SUBJECT: SAFETY RECALL NOTIFICATION

SAFETY RECALL

Sr05-14

DATE : November 2005	SECTION : 06
SUBJECT : NEW MULTIPLEX SOFTWARE PROGRAM AND INSTALLATION OF NEW WIPER HARNESS

FIGURE 1: CABLE ROUTING

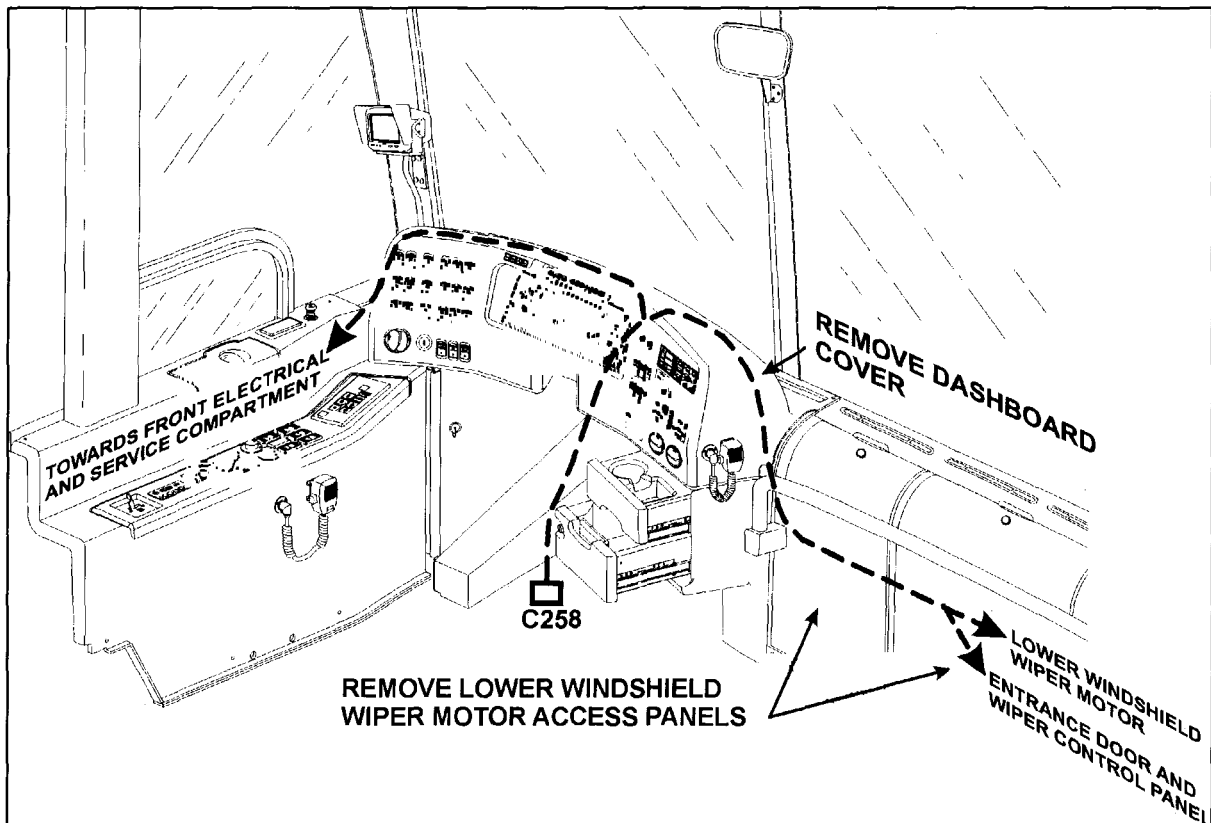
1. Remove dashboard cover and lower windshield wiper motor access panels (Refer to figure 1).
2. Disconnect connector C258 located at the base of steering column. Connect connector C258 of the new harness (066734) with cable coming from steering column multifunction lever.
3. Route cable end labeled "wipers" through inside of the dashboard and behind the driver's HVAC unit, towards the lower windshield wiper motor and the entrance door and wiper control panel; route the other end towards the front electrical and service compartment. Make sure the harness is properly secured using nylon ties by following the necessary precautions (Refer to figure 1).

FIGURE 2: FRONT ELECTRICAL AND SERVICE COMPARTMENT

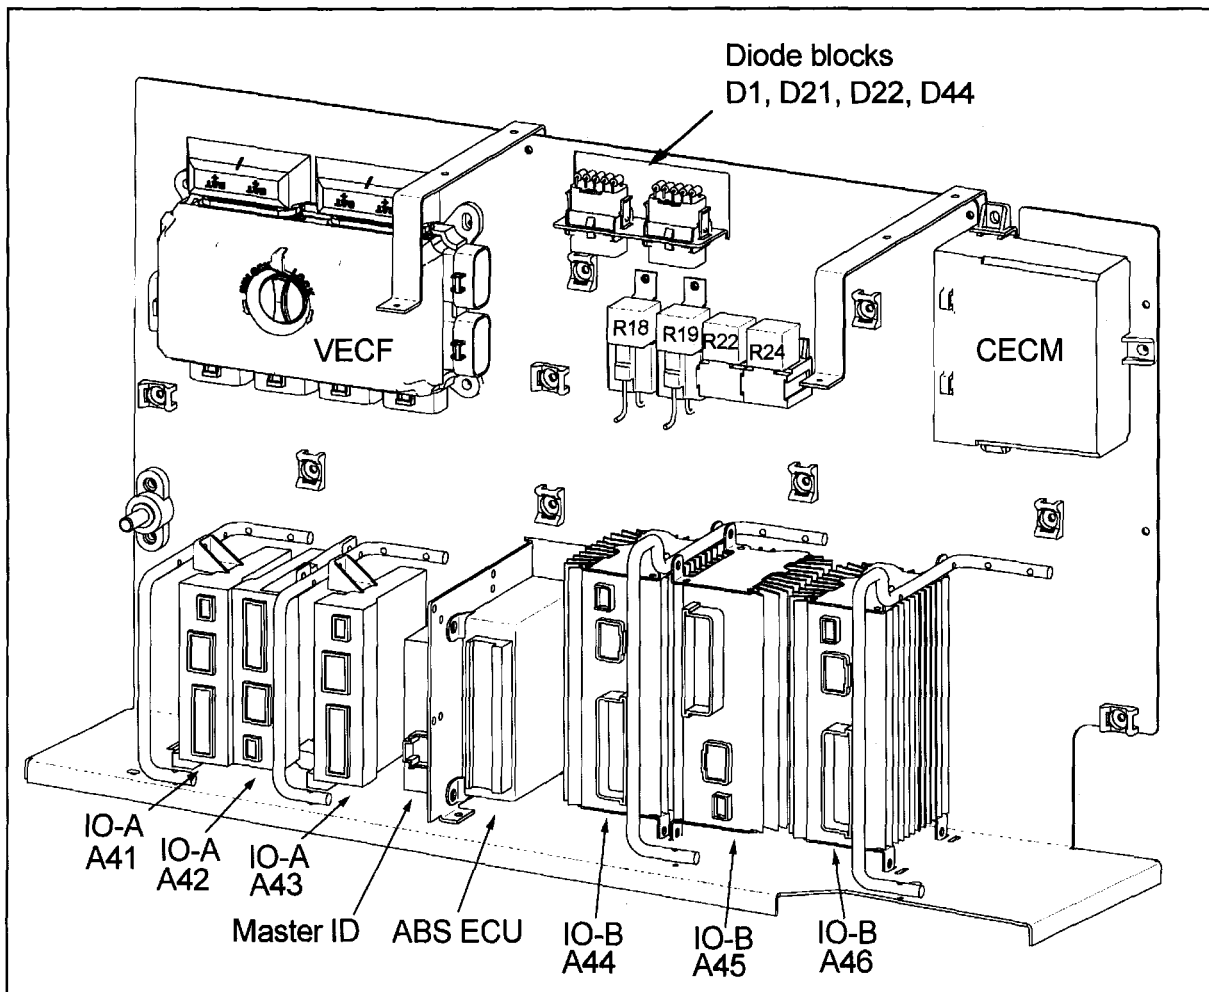
- Inside front electrical and service compartment, solder wire 24V17 of the new harness with wire 24V17 of RED connector VECF2-F;

- Connect wire 64A of the new harness into connector J1, socket number 5 of module A43;
- Remove wire 64A from connector J1, socket number 20 of module A43. Cut heat shrink tubing up (561918) into four 3-inch long pieces and cover wire end with heat shrink tubing;
- Remove wire 59 from connector J1, socket number 8 of module A43 and cover wire end with heat shrink tubing, connect wire 59 of the new harness into connector J1, socket number 8 of module A43;
- Connect wire 53D of the new harness into connector J1, socket number 9 of module A44;
- Remove wire 53D from connector J1, socket number 9 of module A46 and cover wire end with heat shrink tubing;

- Connect wire 53C of the new harness into connector J1, socket number 4 of module A42. It is possible that wire 92 be already inserted into this socket, if this is the case; connect wire 92 into connector J1, socket number 2 of module A42 before inserting wire 53C in place;
- Remove wire 53C from connector J1, socket number 8 of module A42;

FIGURE 3: ENTRANCE DOOR AND WIPER CONTROL PANEL

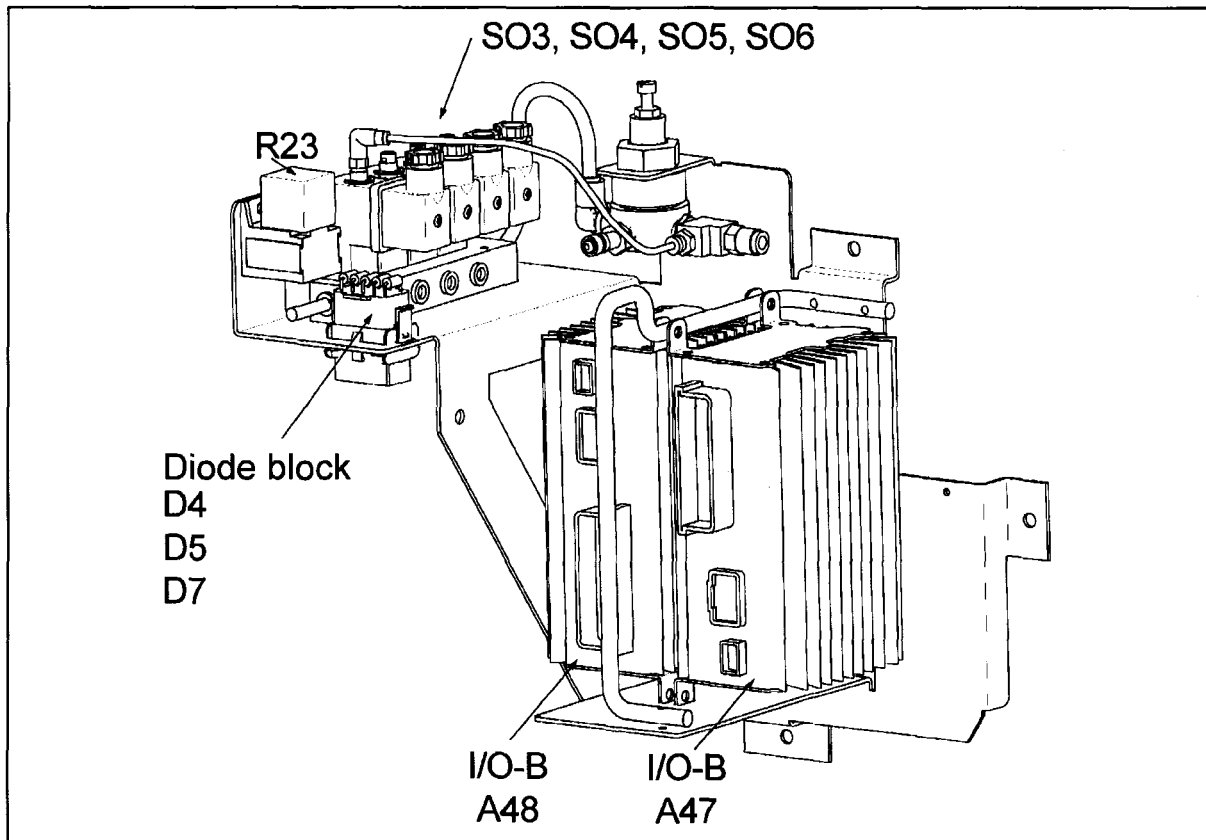
- Remove wire 53B from connector J1, socket number 4 of module A47 and insert into butt splice (562934); insert wire 53B of the new harness into the other end of the butt splice, crimp and heat both ends.
- Remove wire 53G from socket number 30 of relay R23, and insert into butt splice (562934); insert wire 53 of the new harness into the other end of the butt splice, crimp and heat both ends.
- Insert wire 31B of the new harness into socket number 30 of relay R23.
